**UNITED STATES  
NUCLEAR REGULATORY COMMISSION**

**SUBJECT: D. C. COOK NUCLEAR POWER PLANT, UNITS 1 AND 2 – NRC INTEGRATED  
INSPECTION REPORT 05000315/2013003 and 05000316/2013003**

Report No: 05000315/2013003; 05000316/2013003

Facility: D. C. Cook Nuclear Power Plant, Units 1 and 2

Figure 1

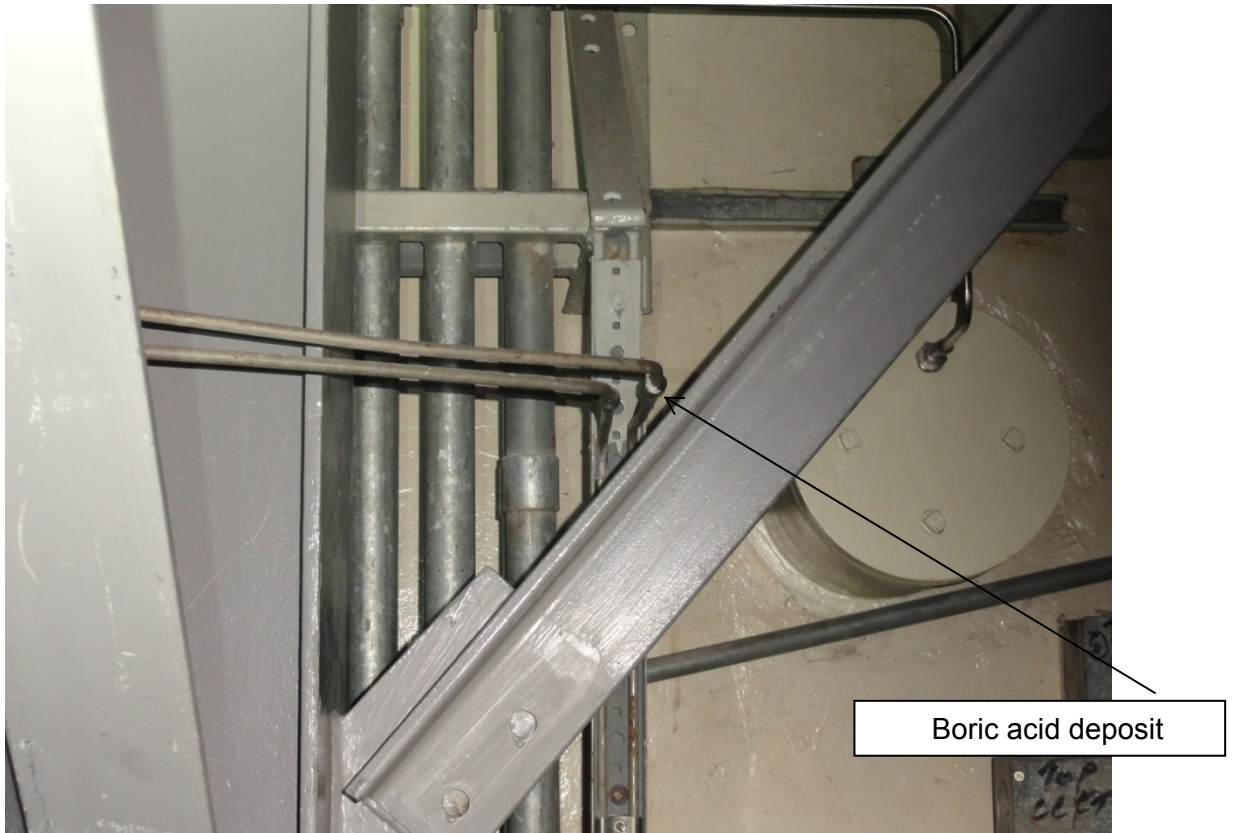
Introduction: The inspectors identified a finding of very low safety significance (Green) with an associated NCV of TS 5.4.1 for failure to implement procedures listed in Regulatory Guide 1.33. Specifically, the licensee's boric acid control program requires boric acid leakage conditions be identified and documented. However, licensee personnel failed to identify a boric acid deposit indicative of a through-wall leak on the RCS 'B' loop flow indicator instrument line.

Discussion: On May 17, 2013, while performing a containment walkdown at Normal Operating Pressure/Normal Operating Temperature, the inspectors noted a boric acid deposit on a 3/8" line. Based on the location, the inspectors concluded that the boric acid resulted from a through wall crack. As seen in Figure 1, the boric acid deposit occurred near a weld and there were no other plausible boric acid sources. The inspectors informed the licensee of the deposit and the licensee cleaned the boric acid. The licensee examined the area and performed a penetrant test to locate the precise location of leak. The test did not reveal a flaw; however, the licensee could not locate another source of the boric acid.

The licensee removed the section of pipe with the flaw and replaced it. However, the licensee did not retain the removed section of pipe. Based on the presence of the boric acid and lack of alternate boric acid sources, the inspectors concluded that a through wall flaw existed through that portion of the reactor coolant pressure boundary. The inspector reviewed the licensee's requirements for boric acid inspections. PLI-5032, Boric Acid Corrosion Control Programs, requires that Boric acid leakage conditions be identified and documented. However, the licensee failed to identify deposit during the refueling outage.
